# **EASTERN DISTRIBUTOR CITY OF SYDNEY**

## **ENVIRONMENTAL IMPACT ASSESSMENT REPORT**

**NOVEMBER, 1985**

Department of Main Roads, New South Wales

**MODIFIED LAYOUT FOR STAGE 1, NORTH OF WILLIAM ST.**

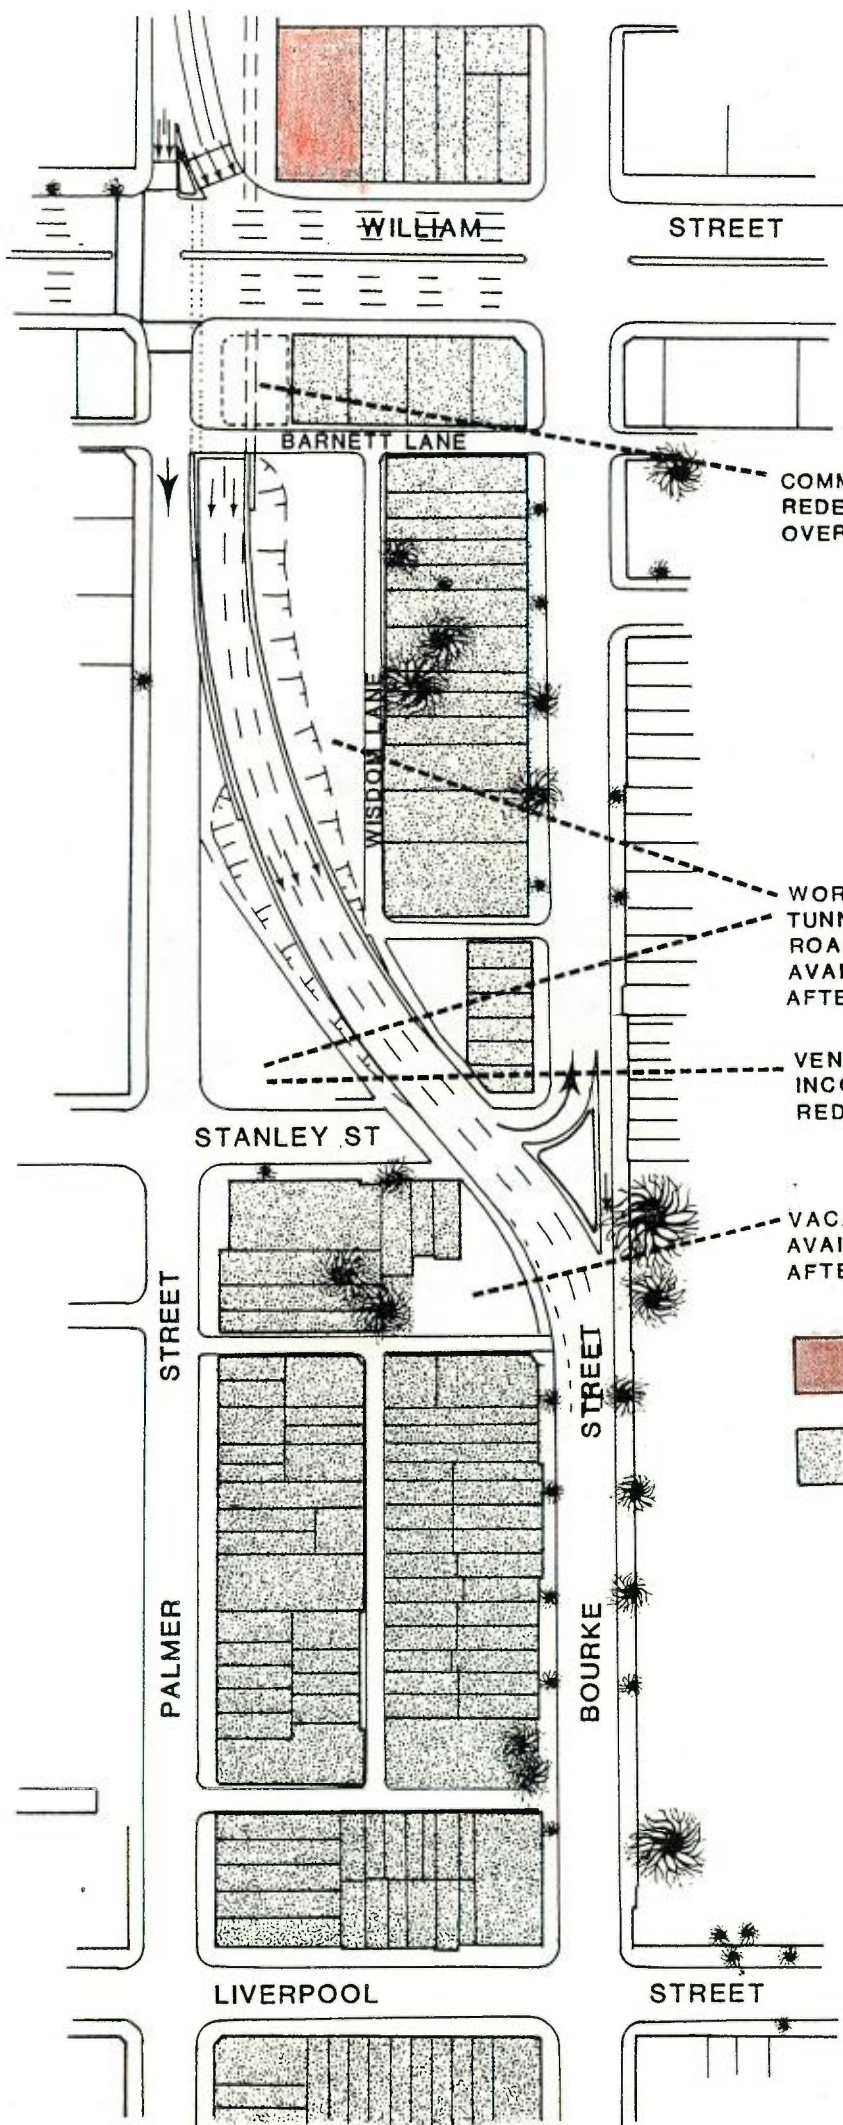
#### 2.2.1 Palmer Street (Figure 1 of this report).

#### 2.2.2 Cathedral Street (Figure 1 of this report).

## MODIFIED LAYOUT FOR STAGE 1, WILLIAM TO STANLEY ST.

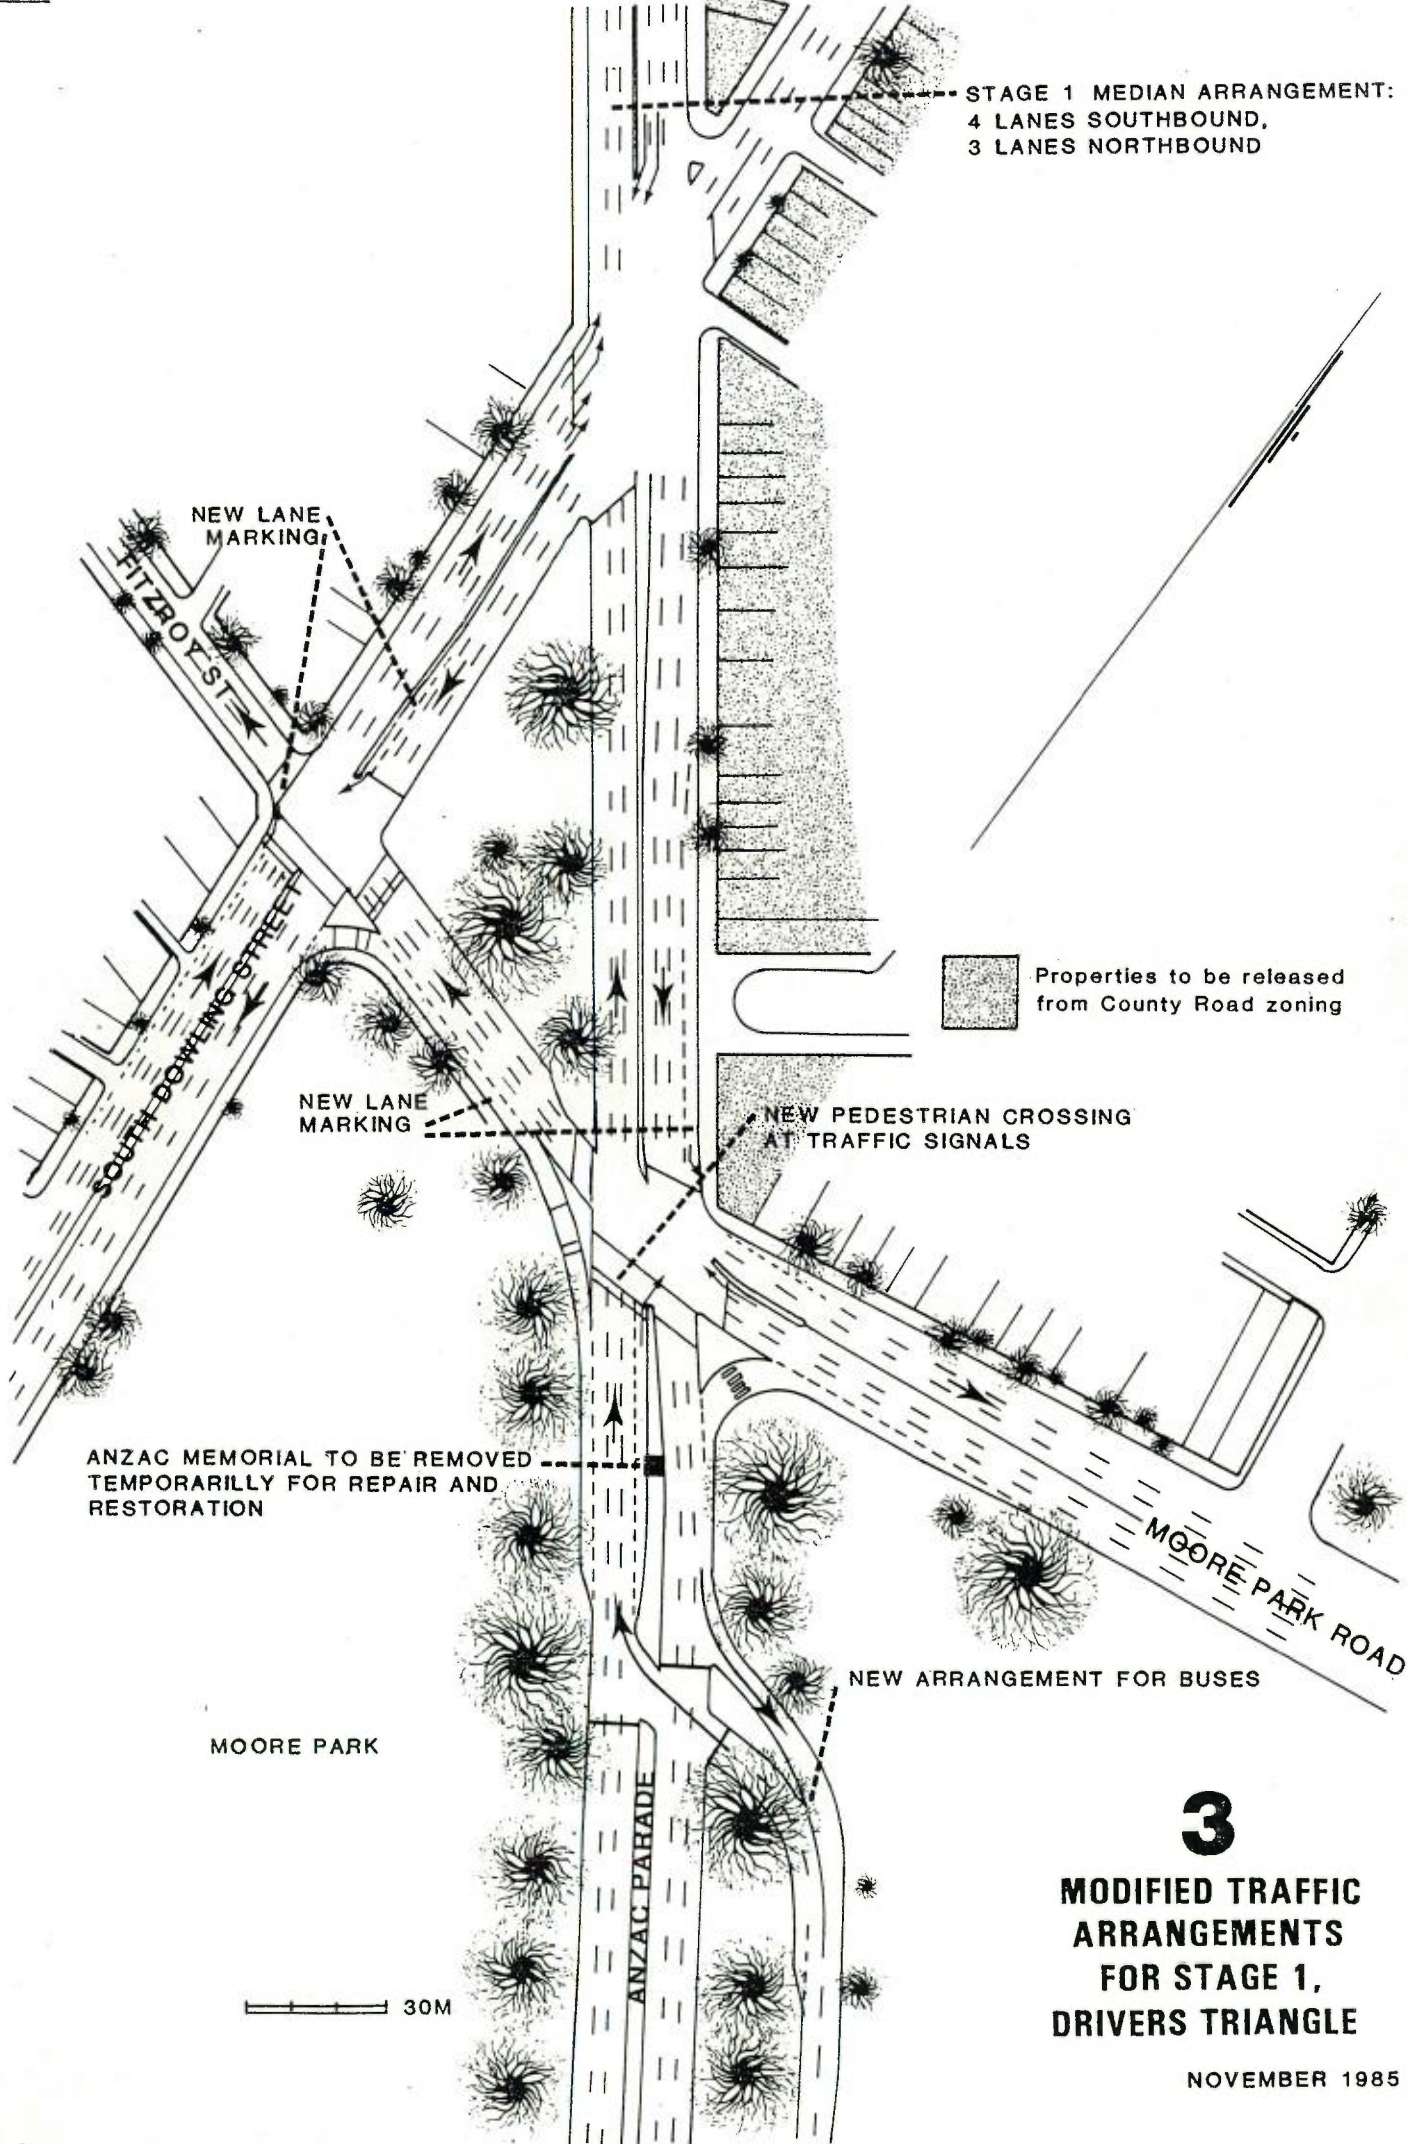
It is proposed that the underpass under William Street be reduced from three lanes to two. This is compatible with the modification to the width of the Stage 2 and 3 tunnels now proposed to be two lanes wide (see Section 2.3.3 below). The two lane underpass of William Street will be adequate for traffic needs and will reduce the width of roadway to be built. It will need to widen to three lanes as it approaches Stanley Street to provide for slower vehicles on the incline.

### 2.2.4 Stanley Street (Figure 2 of this report)

## MODIFIED TRAFFIC ARRANGEMENTS FOR STAGE 1, DRIVERS TRIANGLE

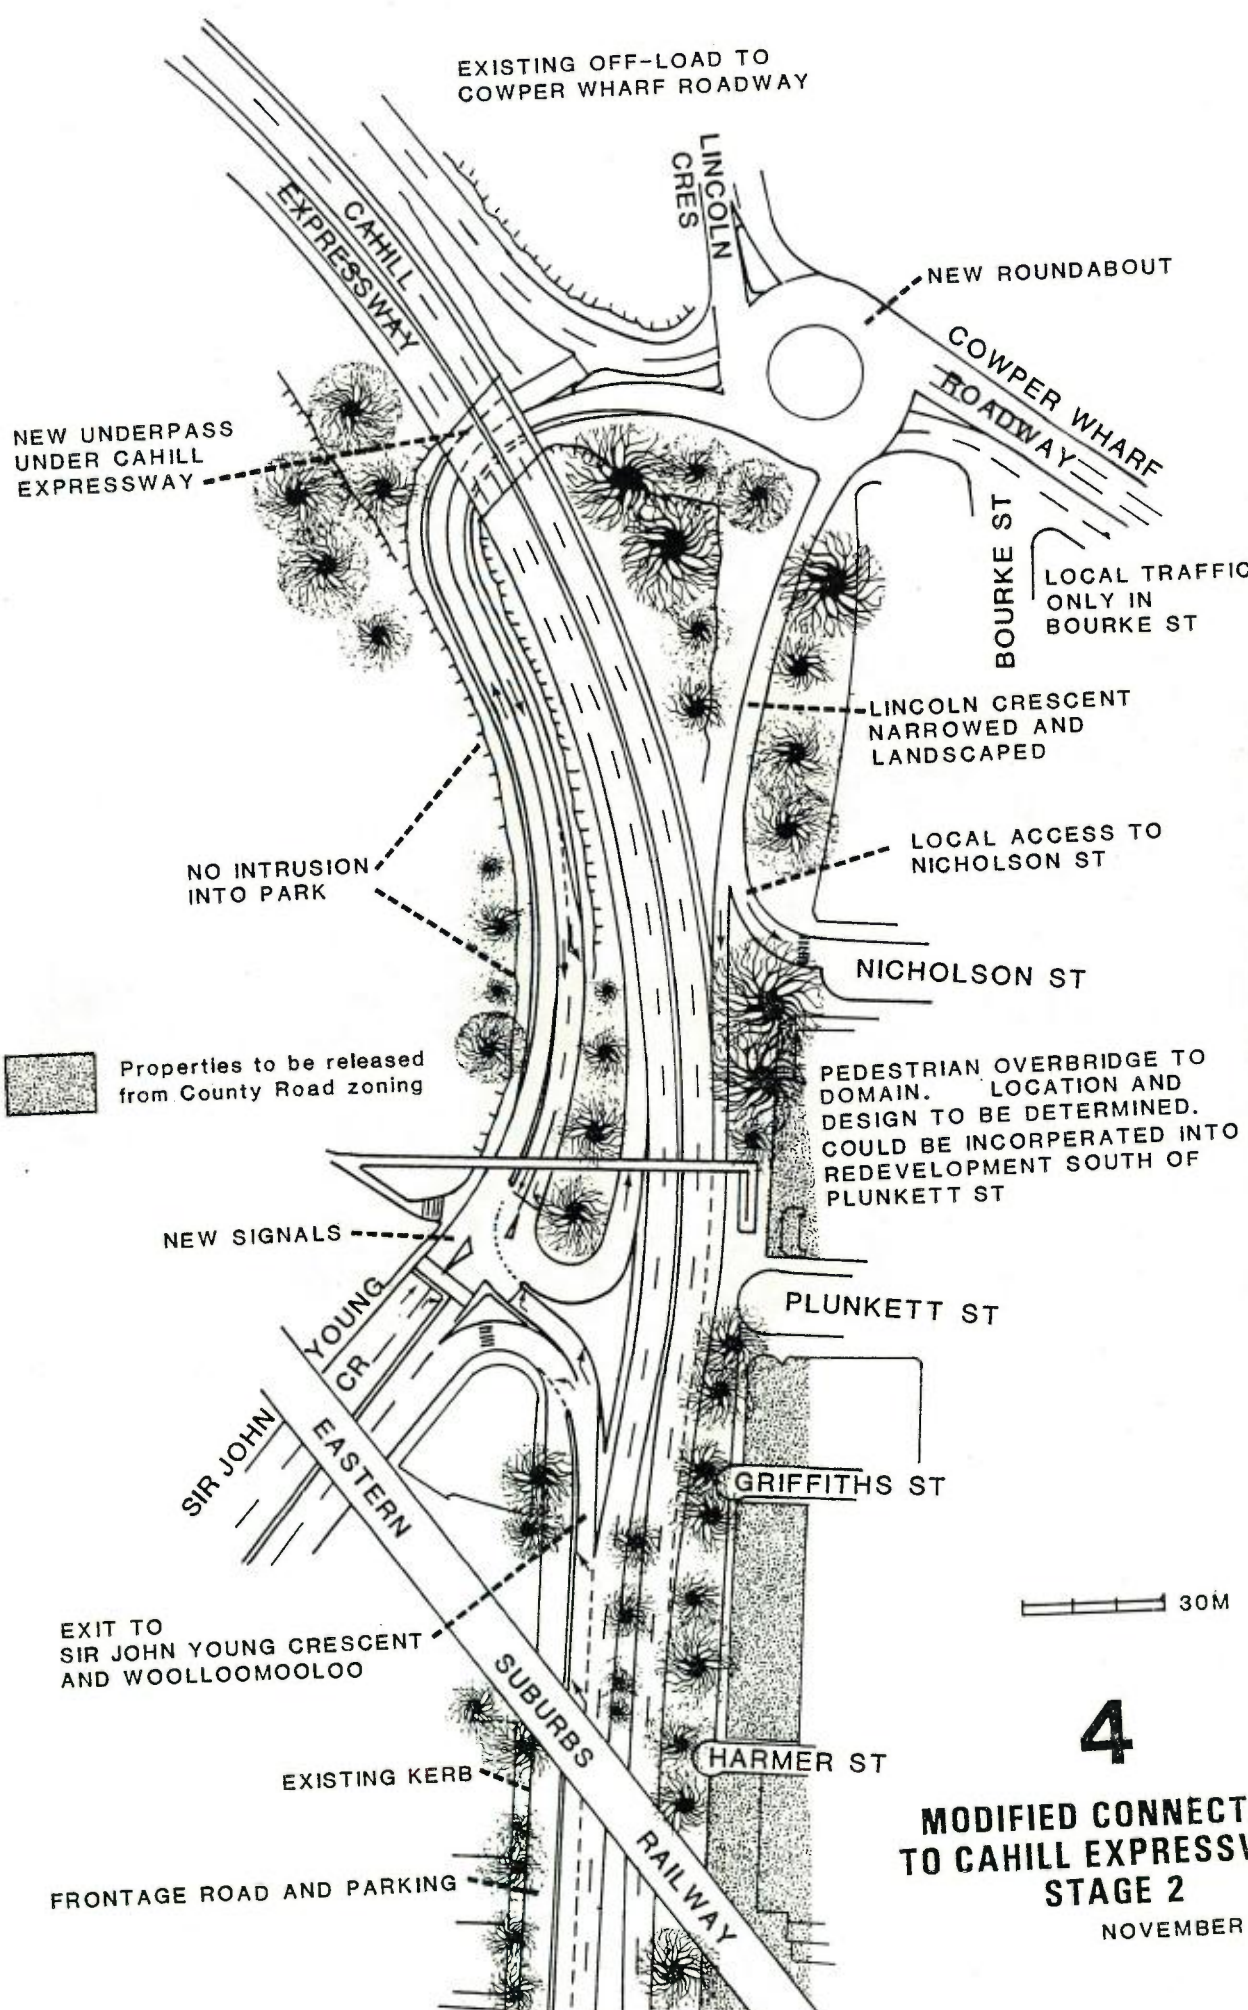
### 2.2.5 Turning Movements from South Dowling Street (Figure 3 of this report)

### 2.2.6 Anzac Parade Memorial (Figure 3 of this report)

The Returned Services League and Sydney City Council have agreed to the moving of the Anzac Parade Memorial. The Department will remove the Memorial and pass it on to Council which will then organise its restoration. It will later be replaced near its present location. It is also likely that one of the four gate posts near the Memorial will need to be removed. There is a possibility that Council might relocate all four gate posts after a similar restoration.

MODIFIED CONNECTION  
TO CAHILL EXPRESSWAY,  
STAGE 2

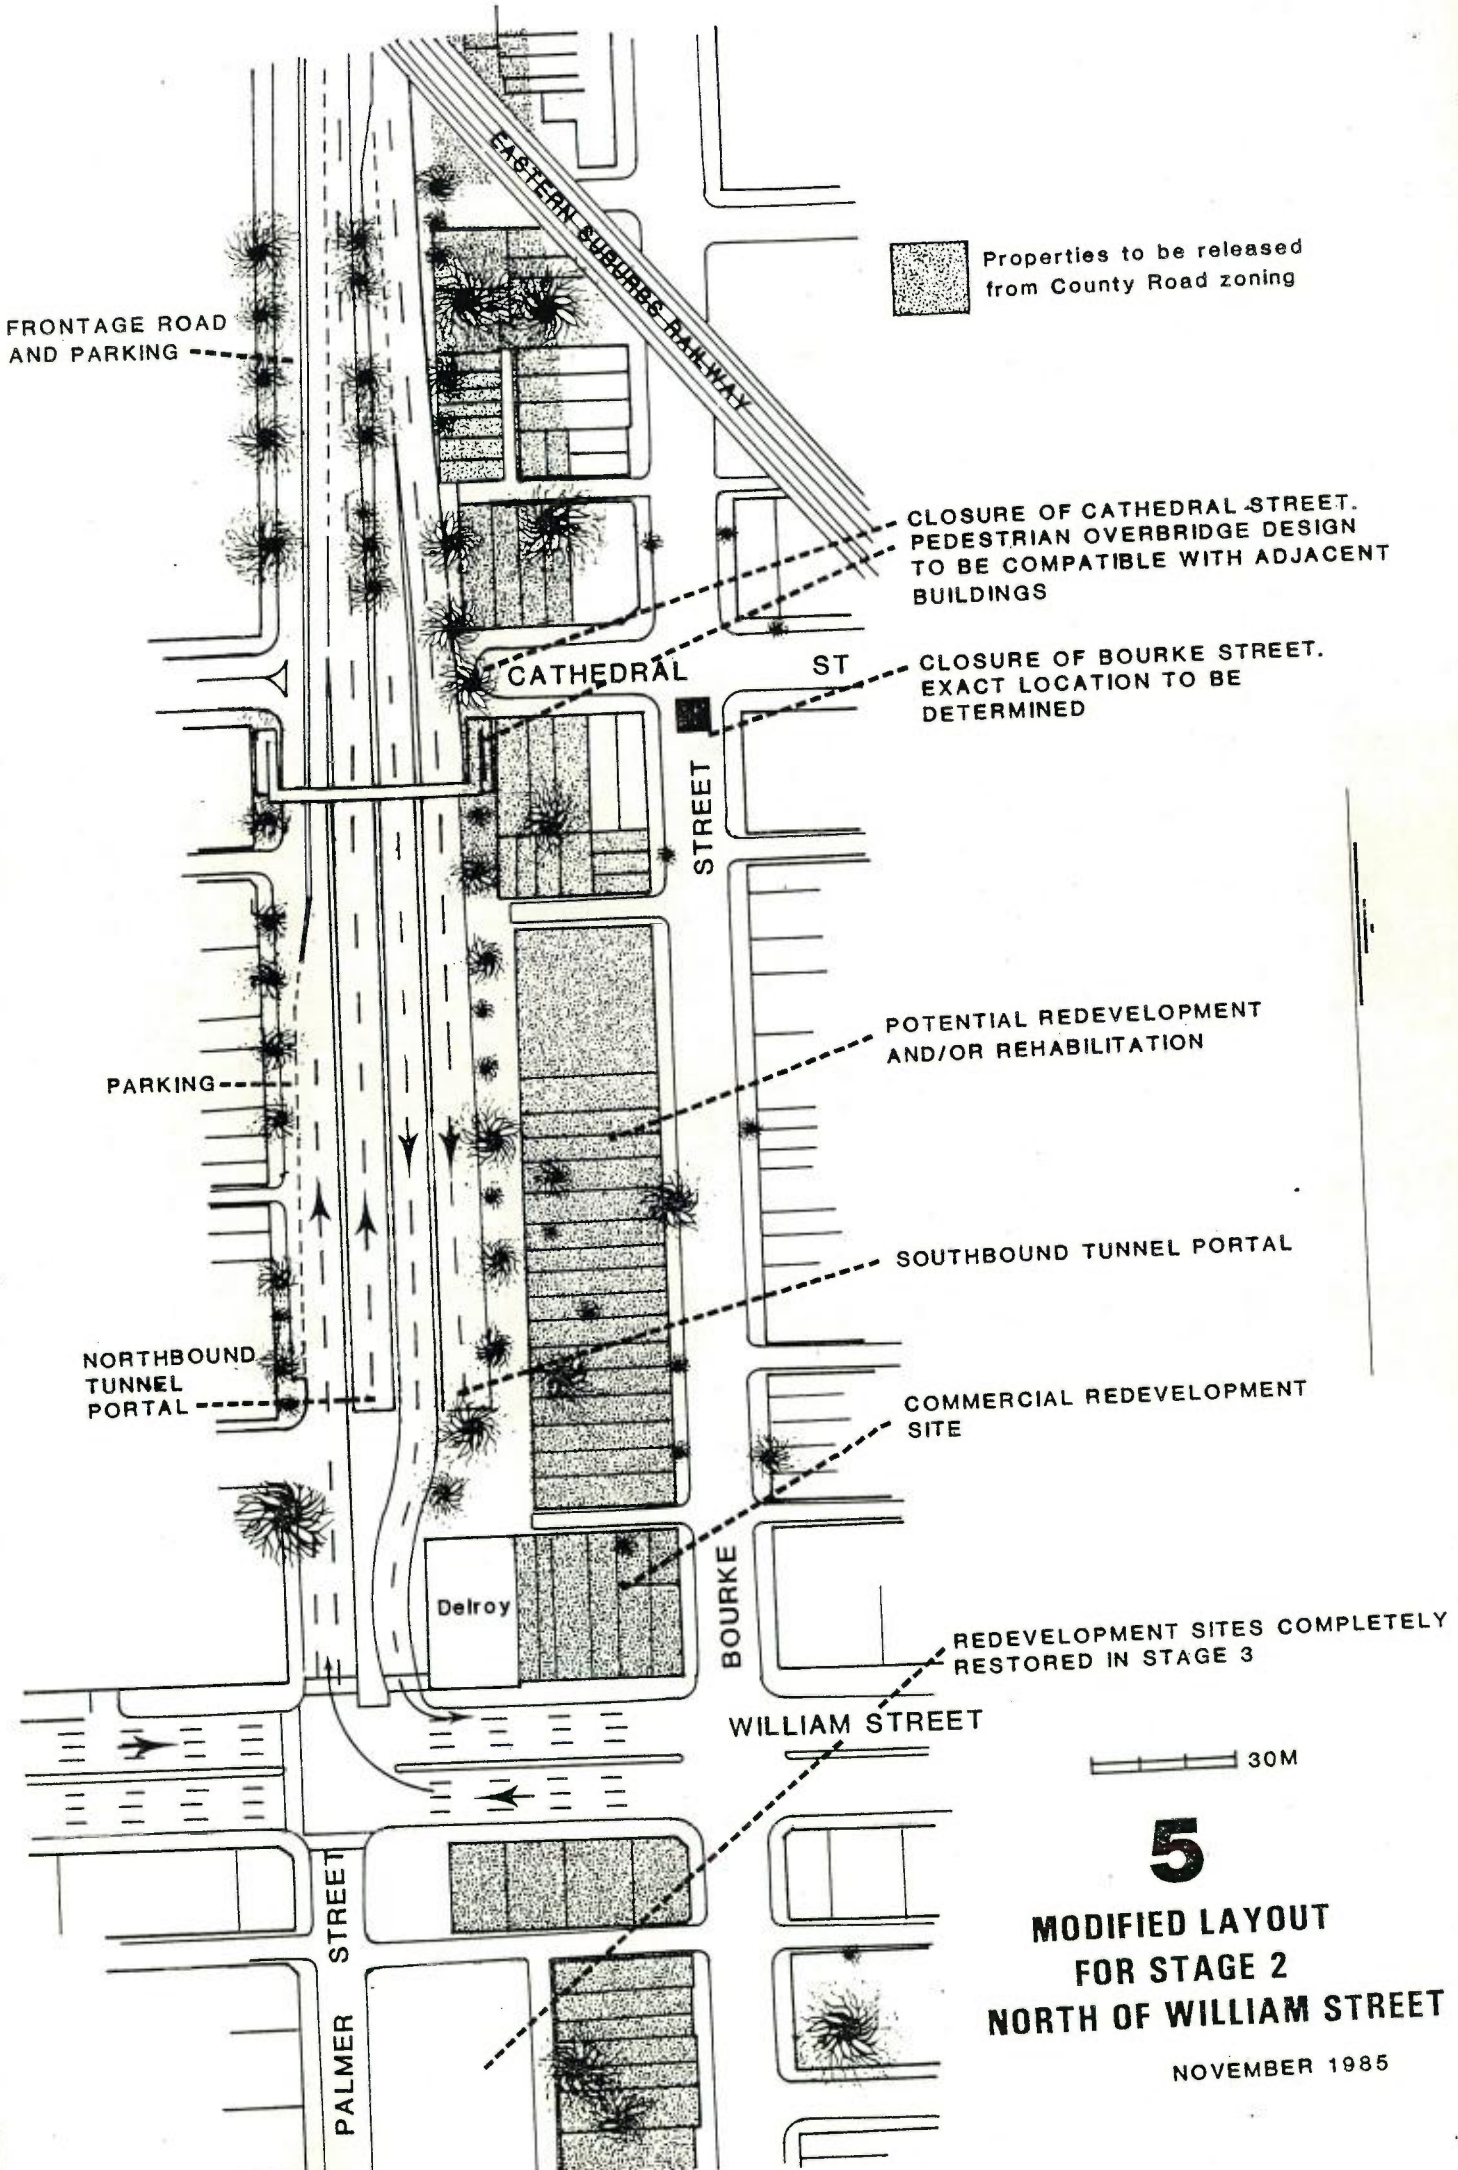
### 2.3.1 Connection with the Cahill Expressway (Figure 4 of this report)

Figure 2.14 of the EIS indicated the proposed layout of the connection between the Cahill Expressway and the Eastern Distributor. It comprised a signal controlled intersection with Sir John Young Crescent and Plunkett Street, plus an underpass from Cowper Wharf Roadway. Further traffic analysis has shown that this layout has certain deficiencies which require rectification. In particular, the signal controlled intersection would have insufficient capacity to accommodate the predicted volume of traffic and to allow the necessary right turn movements. Also, traffic entering the Cahill Expressway from Cowper Wharf Roadway would create a weaving problem with traffic turning off to Shakespeare Place.

It is proposed that traffic and pedestrian movement at the northern end of the Eastern Distributor be modified as follows (see Figure 4 of this report):

- a two-way underpass will be built under the existing Cahill Expressway to provide for traffic wishing to cross or to turn right on or off the Eastern Distributor; no traffic signals will be needed between the Expressway and the Distributor;
- the southern end of the Cahill Expressway will be shifted slightly to the east to accommodate a two-way connection between Sir John Young Crescent and the underpass; there will be no intrusion into the park.

- traffic to and from Woolloomooloo Bay and Garden Island will use the underpass and will not be required to use the northern end of Bourke Street; Lincoln Crescent will be narrowed to one lane to provide the southbound connection; the residual area will be landscaped; Plunkett Street will be closed;
- a pedestrian overbridge will be provided between Plunkett Street and the Domain footpath west of Sir John Young Crescent; it will also provide access to the west side of Palmer Street and the east side of Sir John Young Crescent; it may be possible to incorporate the eastern end of the overbridge into a redevelopment of the site on the southside of Plunkett Street (to be acquired for the Eastern Distributor).
